REMARKS/ARGUMENTS

AMENDMENT TO THE DRAWINGS

FIG 9

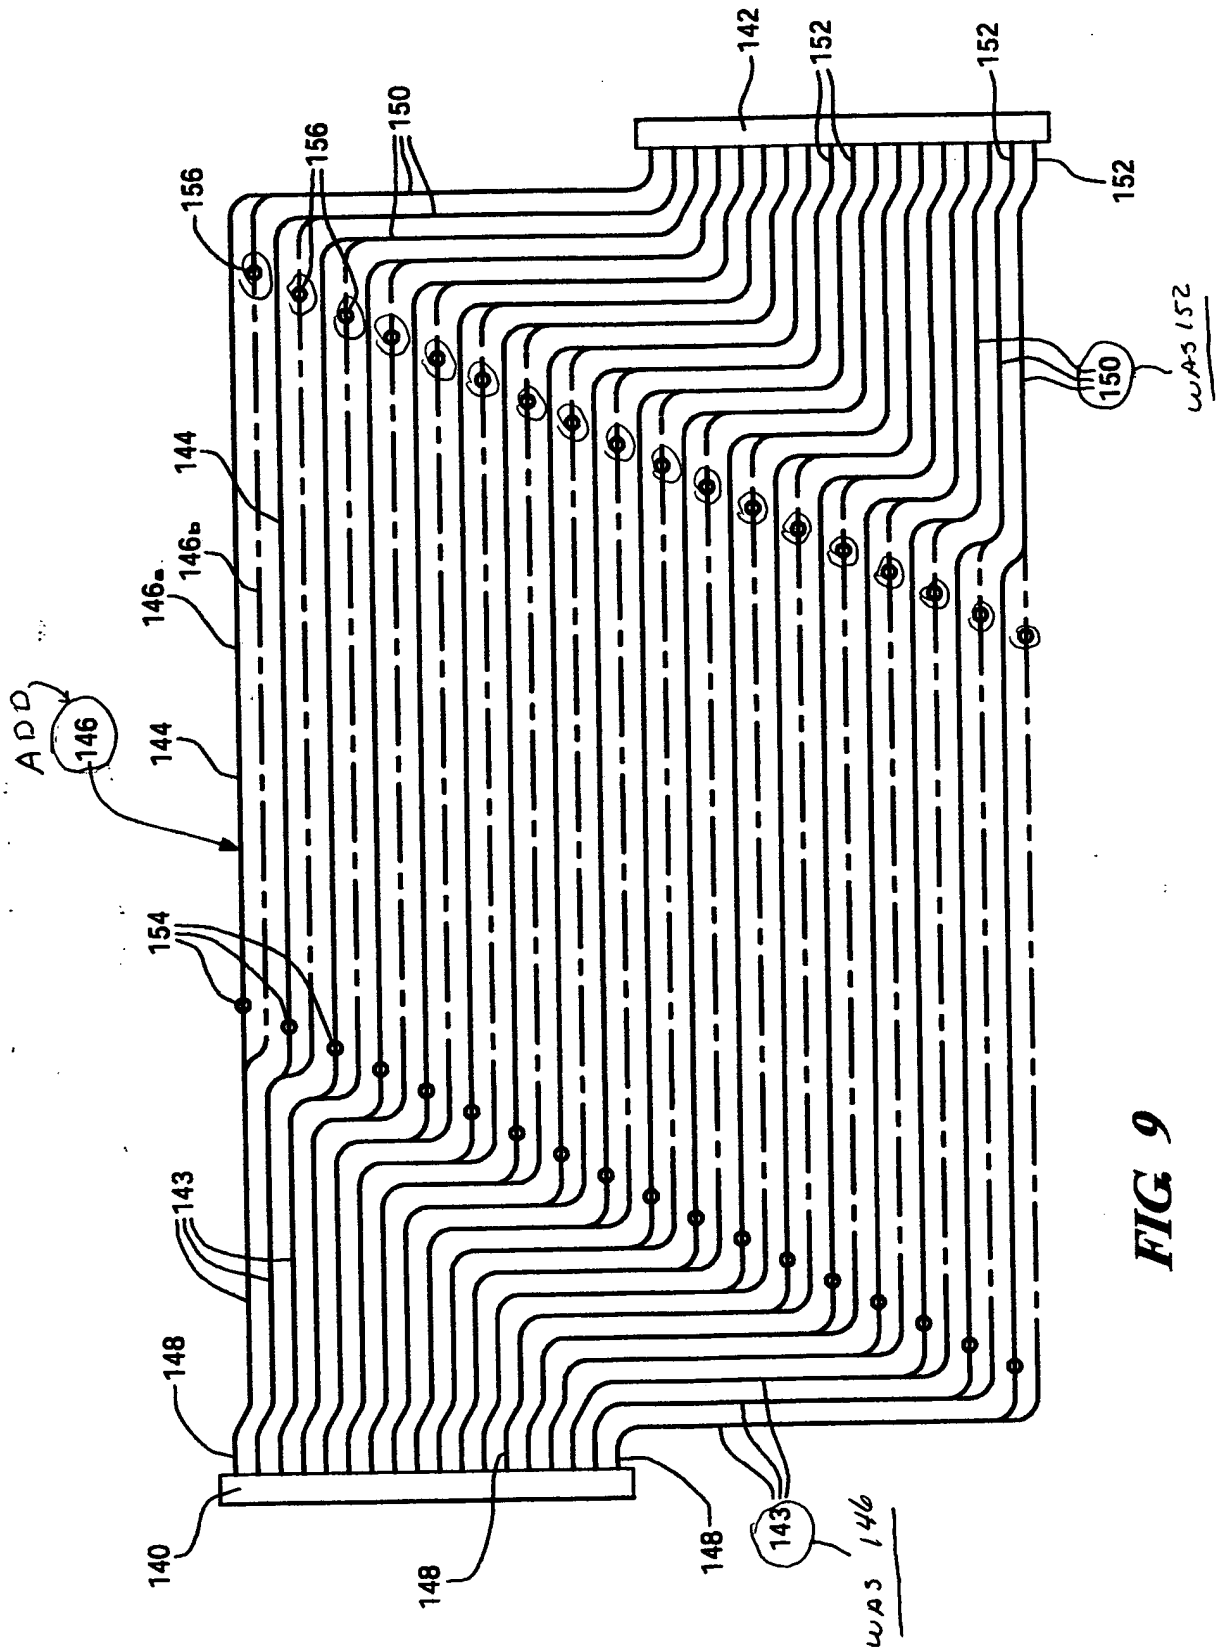
The attached Replacement Sheet of drawings includes changes to Fig. 9 wherein: (1) old number 146 has been changed to 143; (2) new number 146 has been added to designate the medial legs of the flow-channels, (3) old number 152 that designated the exit legs has been changed to 150, and (4) flow-restrictors 156 are relocated from flow-channels 146a to flow-channels 146b. An annotated copy of the drawing, showing the changes in red, is also attached.
